## VGP Service Bulletin 2 – GamesCare Switch Units May 2025

This service bulletin describes modification details for the GamesCare suite of switches (Smart SCART, Automatic Component Switch and SCART Expansion).

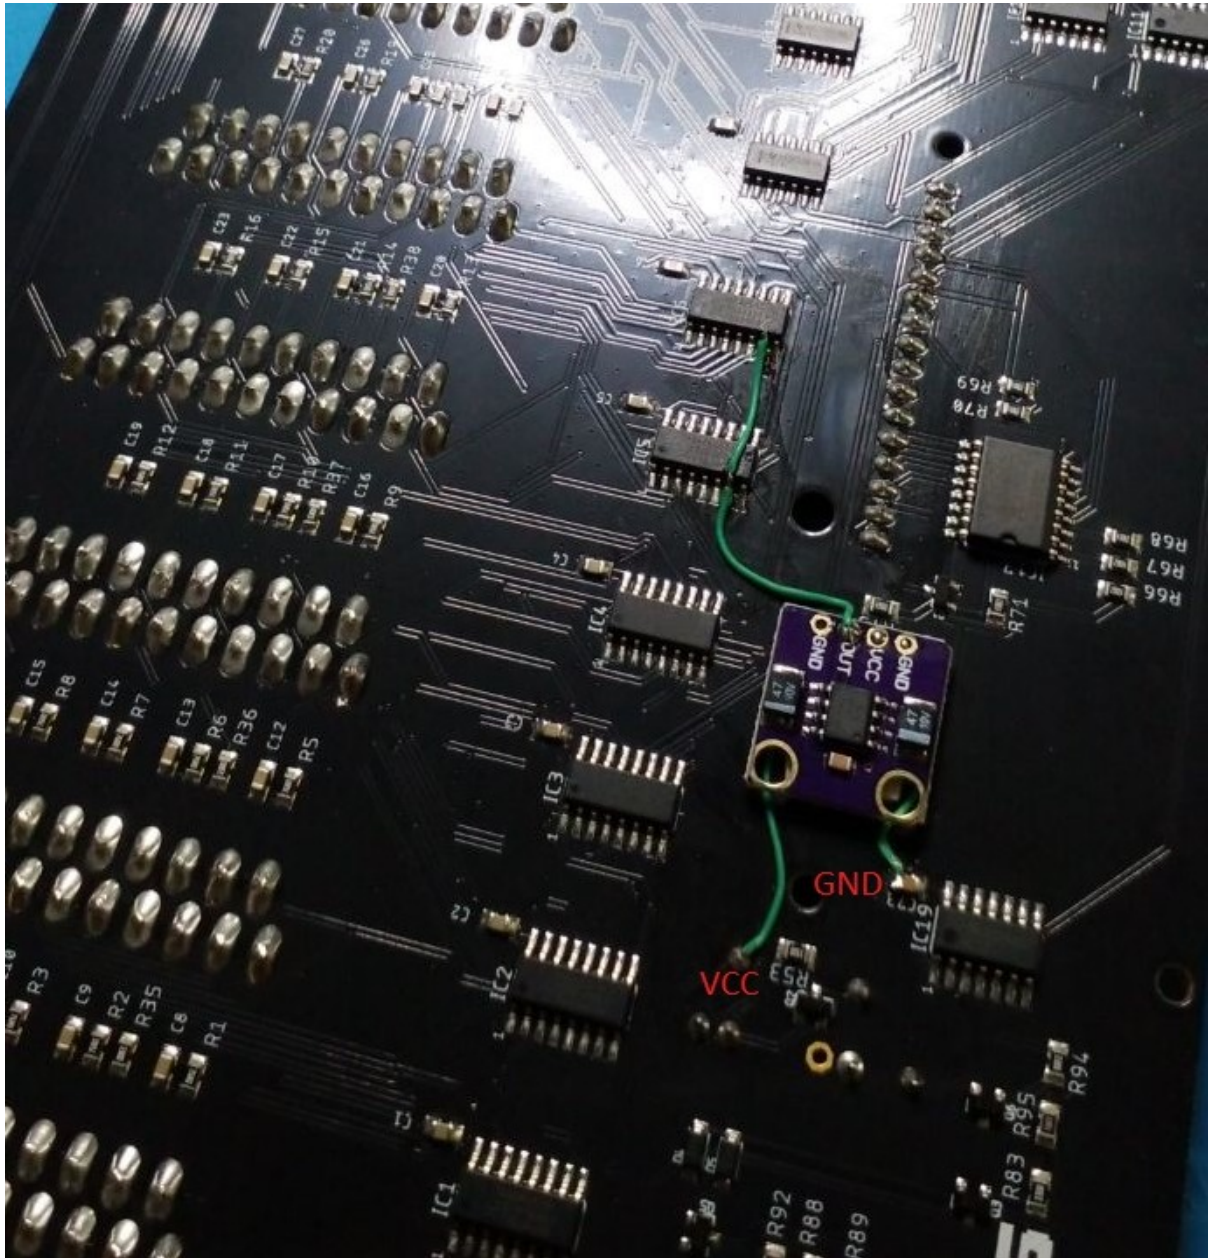
Examine the above image and locate IC's 5 and 6

Using SMD rework tools, remove both IC5 and IC6, these will be replaced with uprated versions of the IC.

Before soldering the new IC5 and IC6 components, lift pin 7 of both IC's, ensuring they are clear of the PCB pads.

When soldering the chips into position, do NOT solder pin 7 on both IC's. Ensure these 2 pins, one on each IC, are both kept clear of the PCB.

Fit the buck convertor in place using a suitable insulated fixing method and wire up as shown in the photo above using Kynar 28 awg hookup wire.

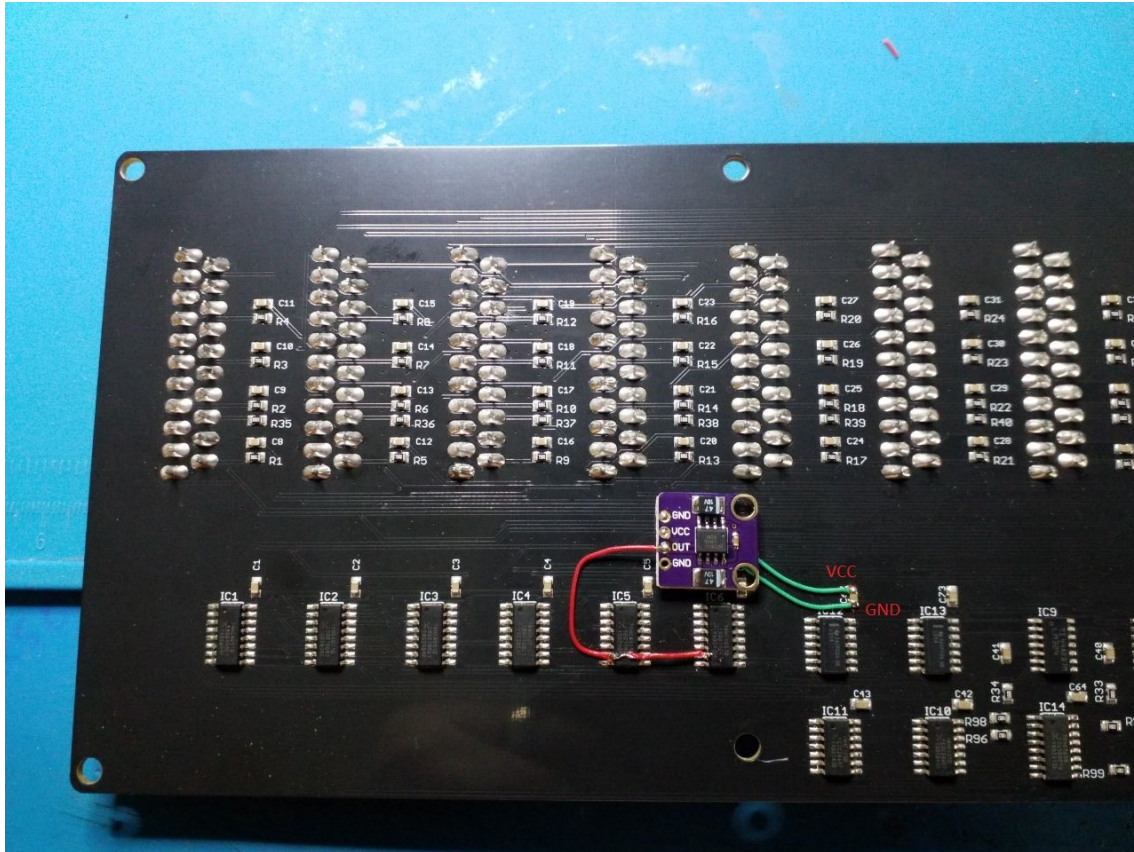
The following image depicts the different component locations compared to the main switch unit.

The circuitry change rework is identical to the main switch unit, apart from there being no op-amp replacement required.
